ADDENDUM #1

September 18, 2026

2027 Roof Replacement at Wyandot Elementary School
Dublin City School District Board of Education
5620 Dublinshire Drive
Dublin, Ohio 43017

Mays Project #: DOH43-011-03

Sheet Name: PARTIAL DOOR PLAN PAGE 010

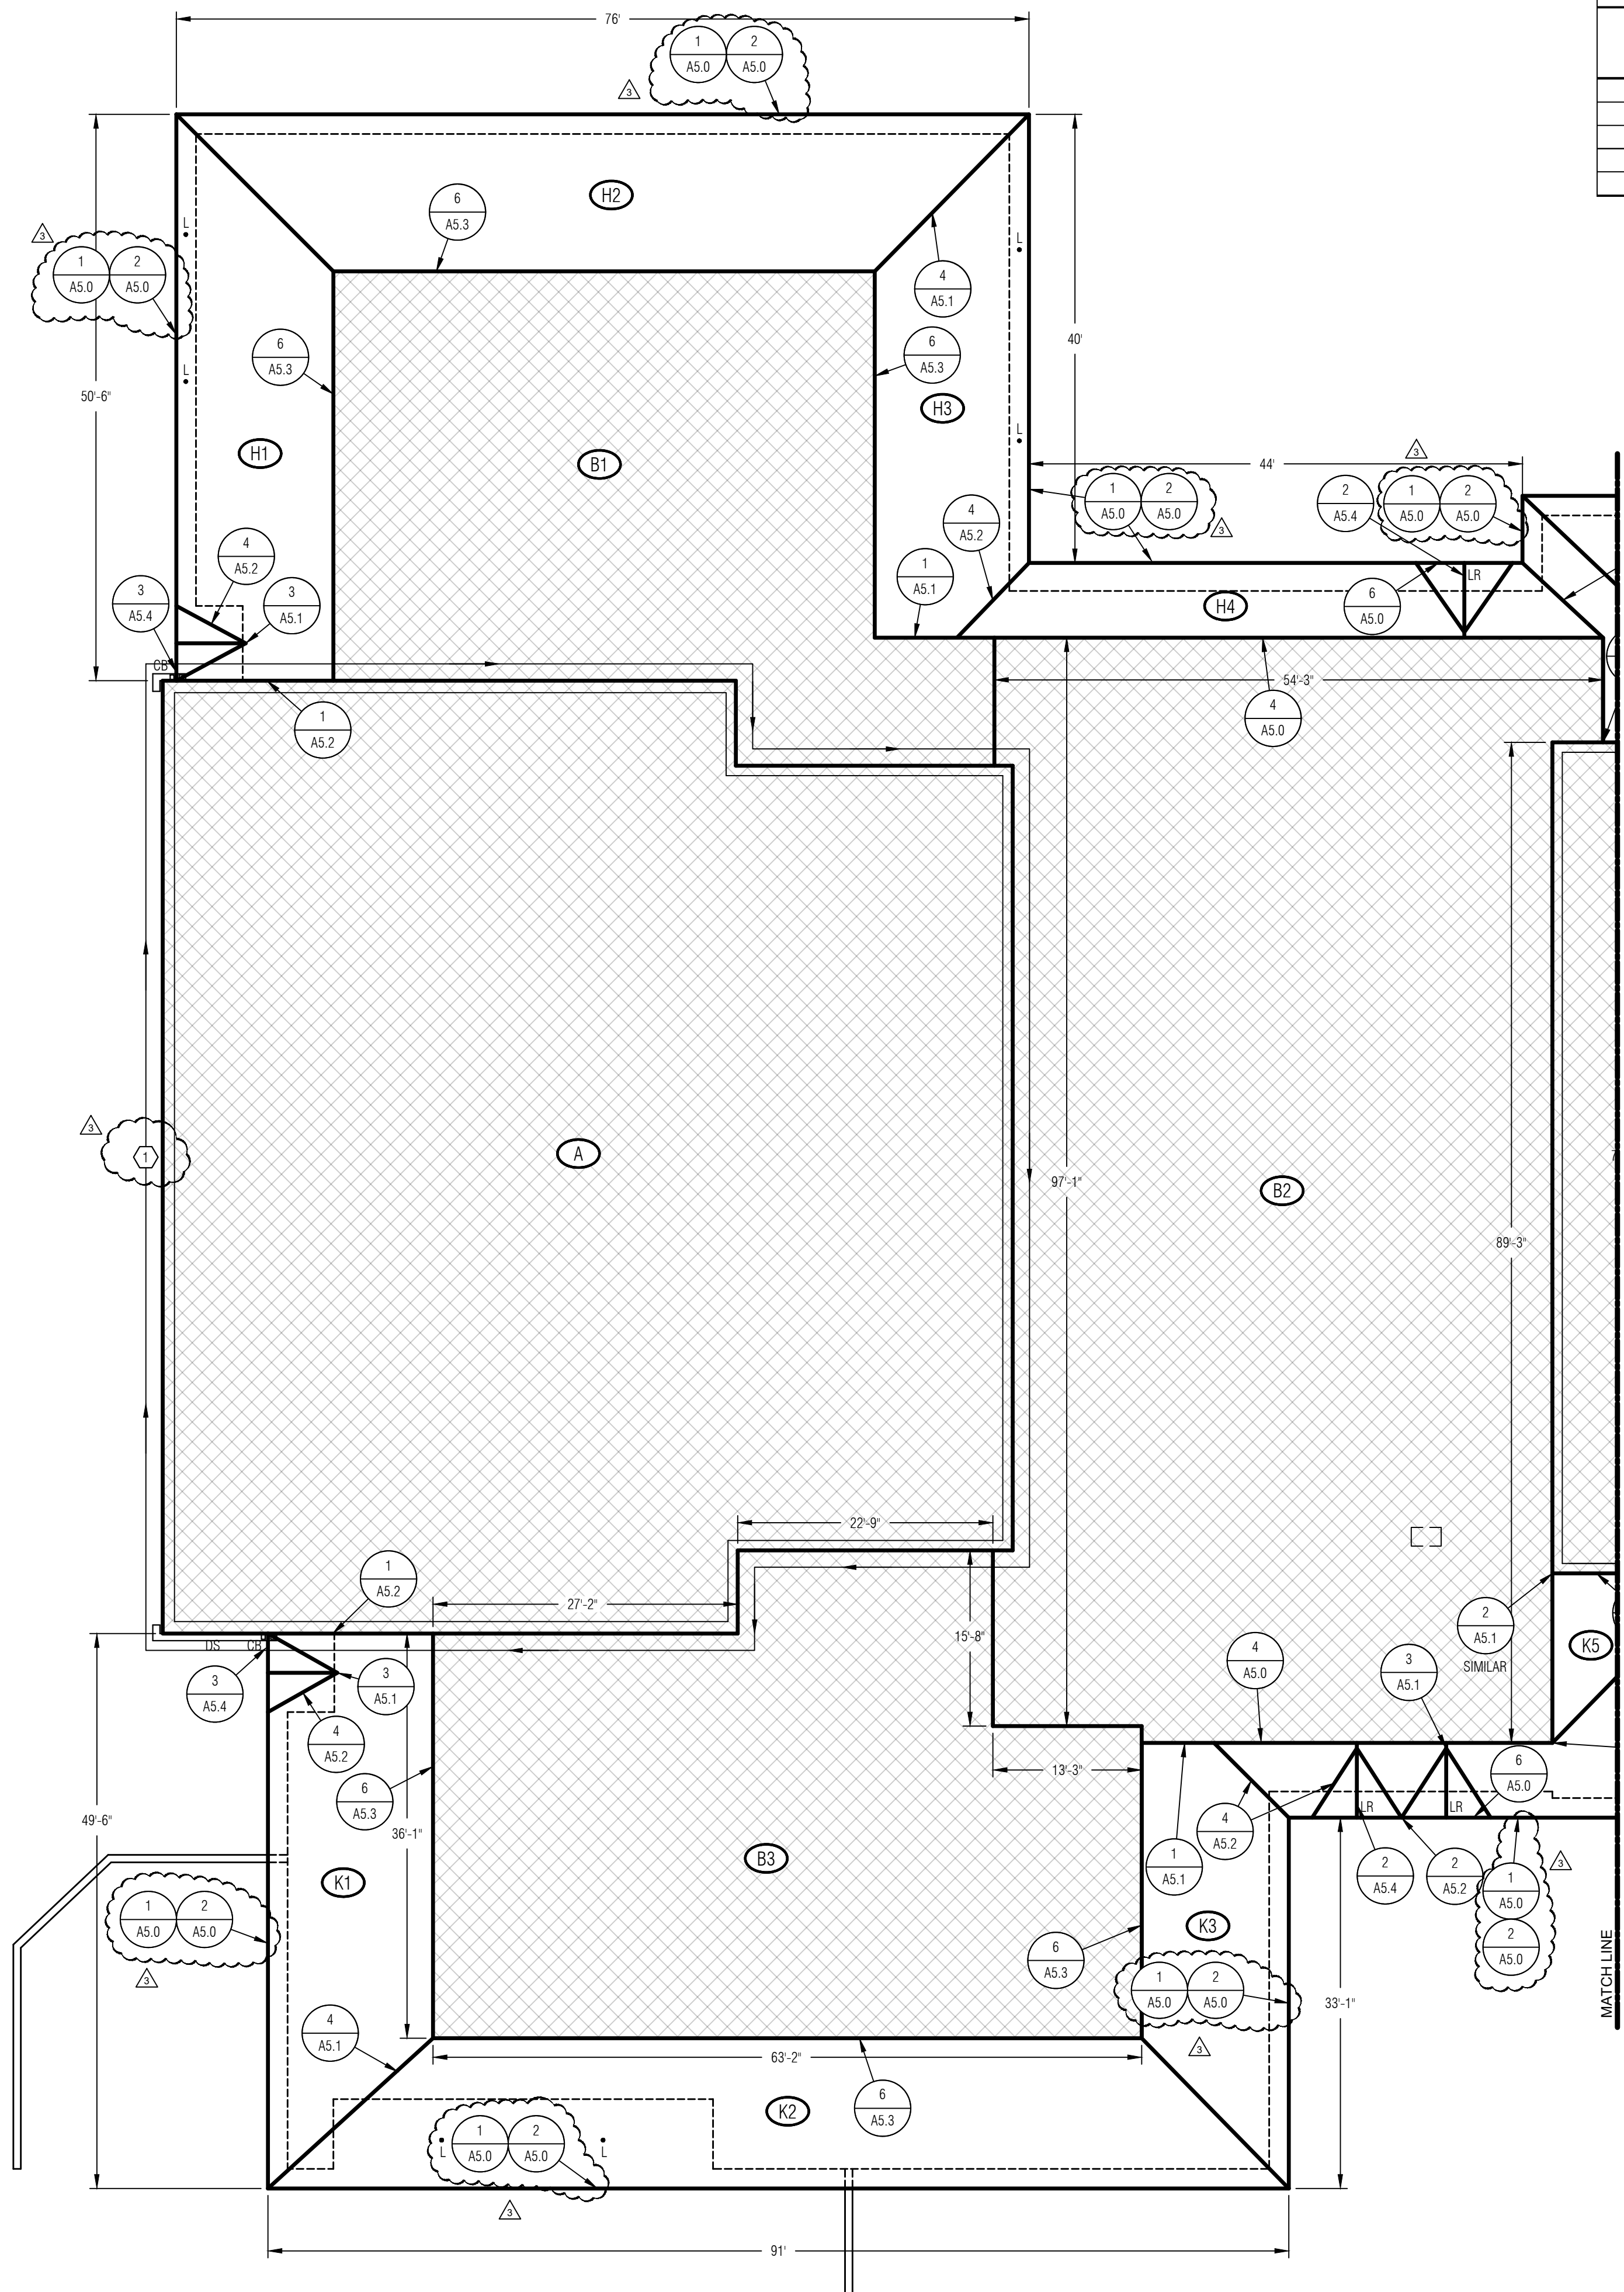
1. **ALTERNATE #3 - REMOVE THE EXISTING COPING CASP SYSTEM (INCLUSIVE OF BASE CLIPS) AND EXTENSION, REPAIR THE EXISTING ROOF MEMBRANE BY HOT-AIR WELDING PVC PATCHES OVER THE EXISTING HOLES OR BY STRIPPING IN THE TOP OF THE WALL WITH NEW PVC ROOF MEMBRANE HOT-AIR WELDED TO THE EXISTING ROOF MEMBRANE. INSTALL NEW METAL-RAE -PERMA-TITE CANTILEVER COPING CASP - SADDLE VERSION AND EXTENDER, SUPPLIED THROUGH A SIKKA-SARNI. SO THAT IT IS INCLUDED AS PART OF THE EXISTING ROOF SYSTEM WARRANTY. THE COLOR OF THE METAL-RAE CANTILEVER COPING CASP SHALL BE MATCHED TO THE EXISTING COPING CASP. SIKKA-SARNI, THE ROOF SYSTEM MANUFACTURER MUST APPROVE THIS MODIFICATION. A WRITING AND ALL WORK MUST BE PERFORMED BY A SIKKA-SARNI AUTHORIZED CONTRACTOR, CONTRACTOR RESPONSIBLE FOR ANY INSPECTION COSTS REQUIRED BY SIKKA-SARNI AS PART OF THIS MODIFICATION.**

PARTIAL ROOF PLAN - BASE BID

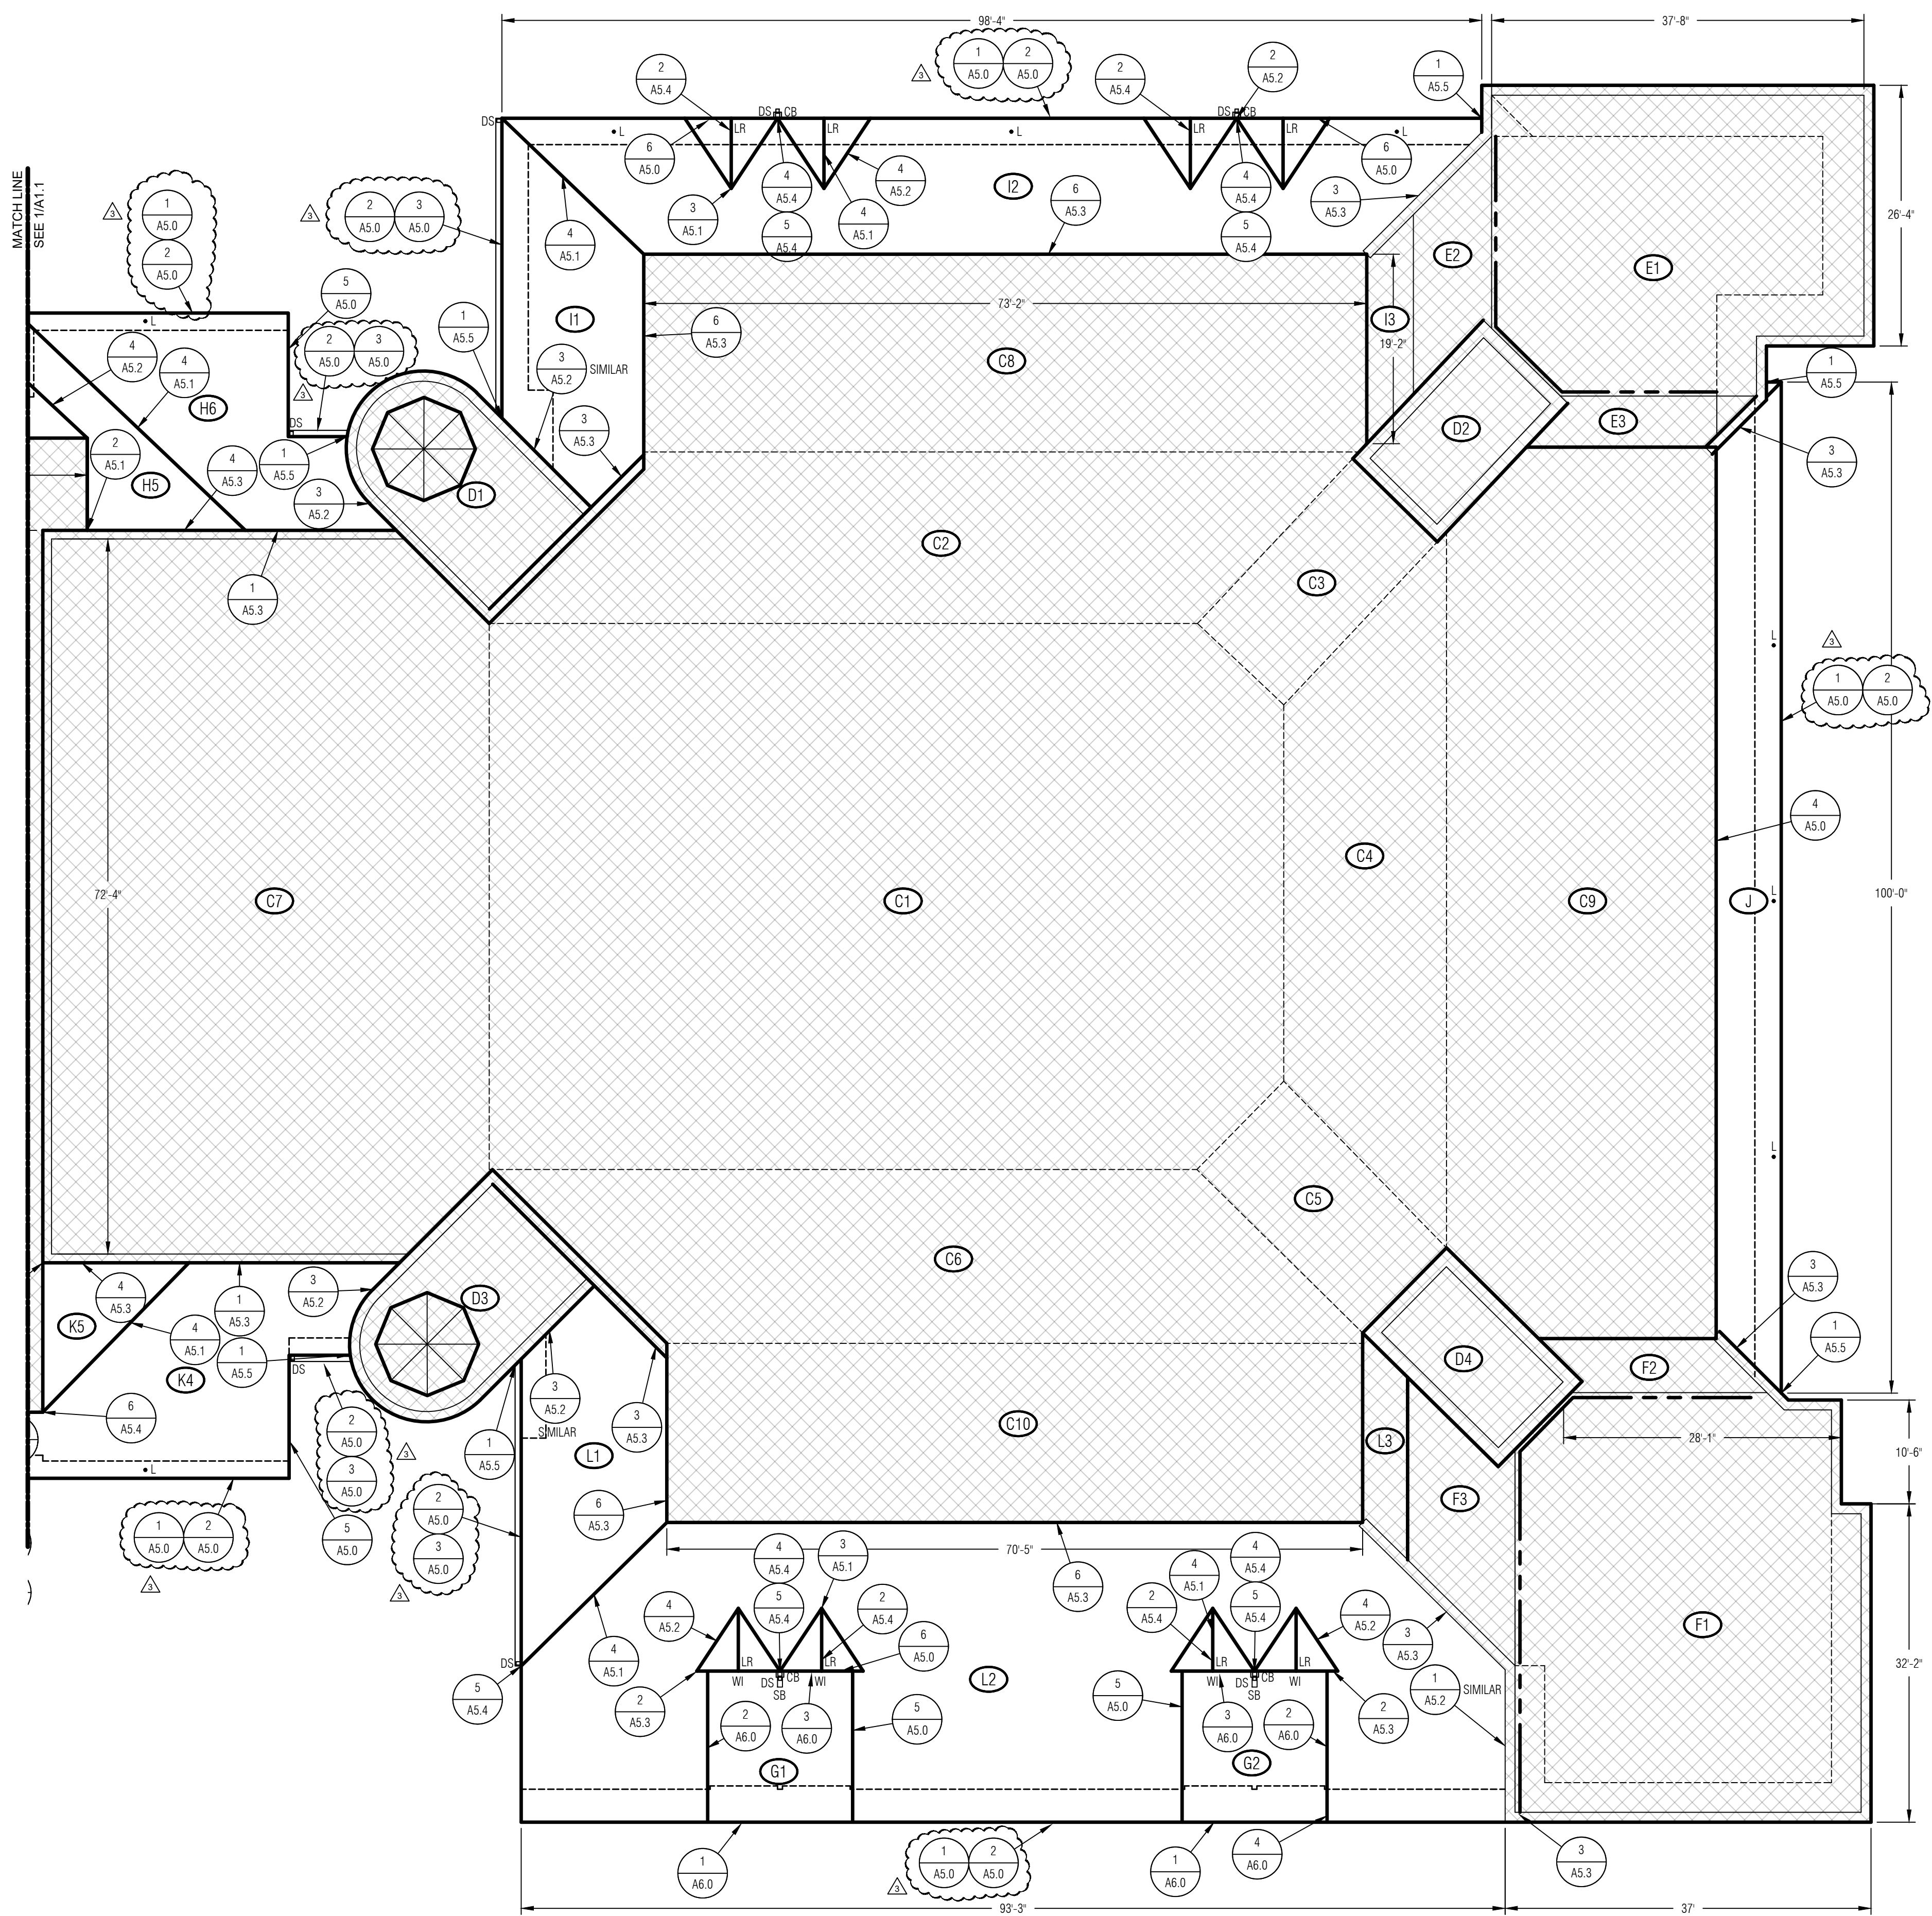
1 ALTERNATE #3 - REMOVE THE EXISTING COPING CAP SYSTEM (INCLUSIVE OF BASE CLIPS) AND EXTENSION, REPAIR
THE EXISTING ROOF MEMBRANE BY HOT-AIR WELDING PVC PATCHES OVER THE EXISTING HOLES OR BY STRIPPING
IN THE TOP OF THE WALL WITH NEW PVC ROOF MEMBRANE HOT-AIR WELDED TO THE EXISTING ROOF MEMBRANE.
INSTALL NEW METAL-RAE PERMA-TITE CANTILEVER COPING CAP - SADDLE VERSION AND EXTENDER, SUPPLIED
THROUGH SIKKA SARFAM SO THAT IT IS INCLUDED AS PART OF THE EXISTING ROOF SYSTEM WARRANTY. THE
2 NEW METAL-RAE PERMA-TITE CANTILEVER COPING CAP SHALL BE SUPPLIED THROUGH SIKKA SARFAM. THE
SIKA SARFAM ROOF SYSTEM MANUFACTURER MUST APPROVE THIS MODIFICATION IN WRITING AND ALL
WORK MUST BE PERFORMED BY A SIKKA SARFAM AUTHORIZED CONTRACTOR. CONTRACTOR RESPONSIBLE FOR
ANY INSPECTION COSTS REQUIRED BY SIKKA SARFAM AS PART OF THIS MODIFICATION.

4 SHINGLE - HIGH SIDE DETAIL
SCALE: NONE

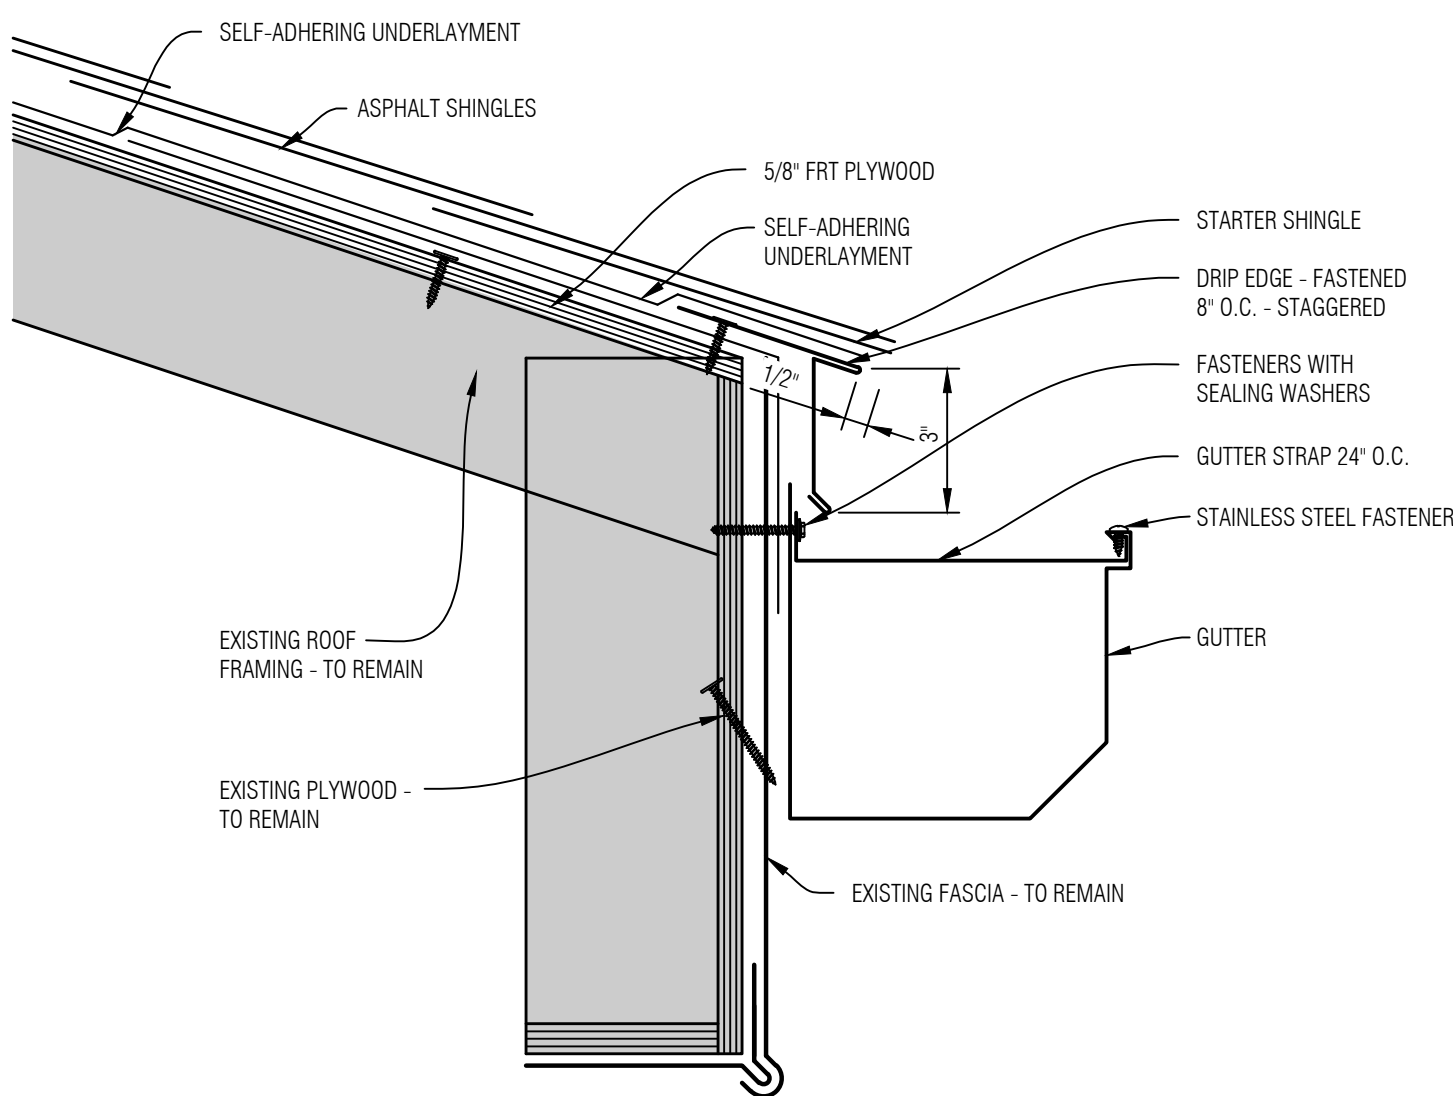
Drawing No(s):	4/A5.0 and 6/A5.3		
Request:	Does approval from the low-sloped membrane manufacturer need to be obtained for the flashing at the high side vent assembly. If conditions are discovered during removal and resetting of the vertical ridge that require modifications or repairs to the newly installed PVC membrane, please confirm whether the original roofing contractor will be readily available to perform the necessary corrective work so the existing manufacturer's warranty is not affected or voided.		
Recommendations:			
Impact:	N/A		
Attachment(s):	N/A		
Requested by:	Erin Bon Ripley, Bill Jackson Roofing	Date of Request:	September 10, 2026
Title:	Estimator	Date Reply Required:	
The high side vent assembly is not a component supplied by the low-sloped roof system manufacturer. We anticipate that the vent assembly will not have to be completely removed (the outer existing flashing may be need to be removed during the course of the work) to complete the steep sloped roofing work and should be able to left in place. Since, the high side vent assembly can be left in place, no approval from the low-sloped roof system manufacturer would be required. If a bidder contemplates needing to modify this flashings attachment to the PVC membrane or damage the existing flashing, that would require modifications to the PVC membrane or attachment, this work will need to be completed by a contractor approved by the existing PVC roof membrane manufacturer (Sika-Sarnafil). The cost for this work will be the responsibility of the bidder.
